BEAVER VALLEY POWER STATION, UNIT NO. 1

AMENDMENT TO FACILITY OPERATING LICENSE

Amendment No. 37
License No. DPR-66

AMENDMENT NO. 37 TO FACILITY OPERATING LICENSE NO. DPR-66

FIGURE 3.6-1 MAXIMUM ALLOWABLE PRIMARY CONTAINMENT AIR PRESSURE VERSUS RIVER WATER TEMPERATURE AND RWST WATER TEMPERATURE

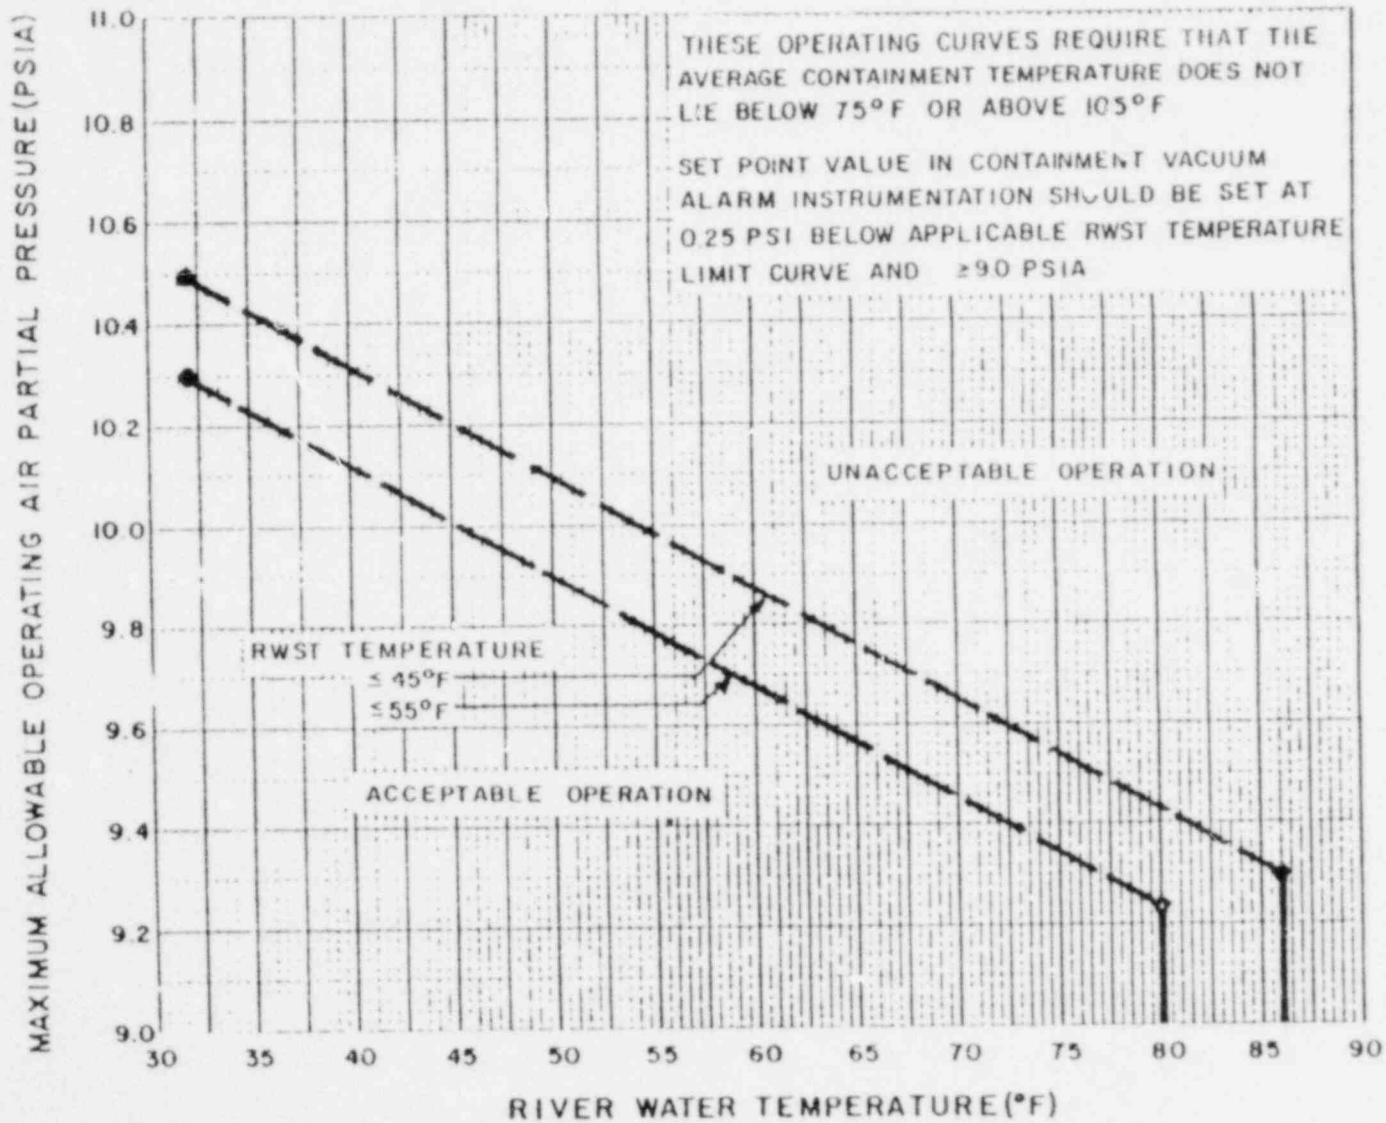
The technical specification for Initial Average Containment Temperature has been incorporated into 3.6.1.5 (Page 3.6-8) and Figure 3.6-1 (Page 3.6-7).
